NAVIGATION - GARMIN SOFTWARE UPDATE TO VERSION 4.8.11

525B (CJ3+)

-0057, -0451 thru -0609

SB525B-34-32
Page 1 of 3

Figure 1. Wiring Modification (Sheet 1)

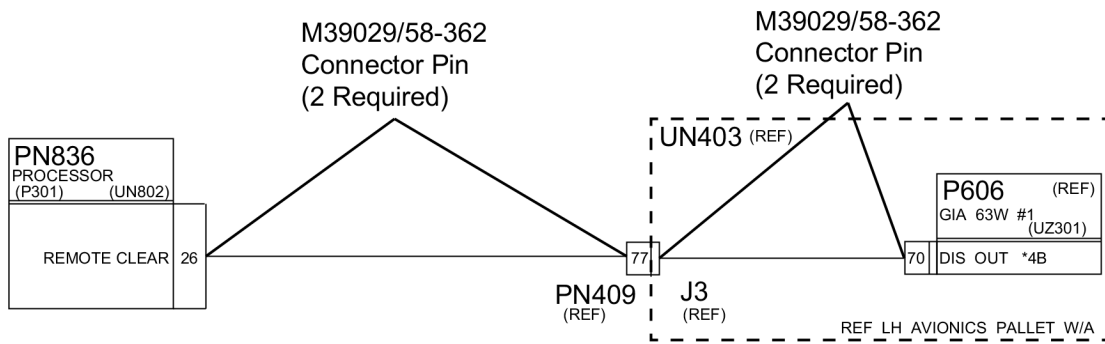
- F. Remove the PN836 electrical connector from the Stormscope processor and the P606 electrical connector from the left GIA63W Integrated Avionics Unit.

- G. Install the 26PN836-77PN409 Electrical Wire with two MS39029/58-362 Connector Pins.
 - H. Install the 77J3-70P606 Electrical Wire using two M39029/58-362 Connector Pins.

- I. Install the PN836 electrical connector in the Stormscope processor and the P606 electrical connector in the left GIA63W Integrated Avionics Unit.

Airplanes Equipped with the Stormscope Option
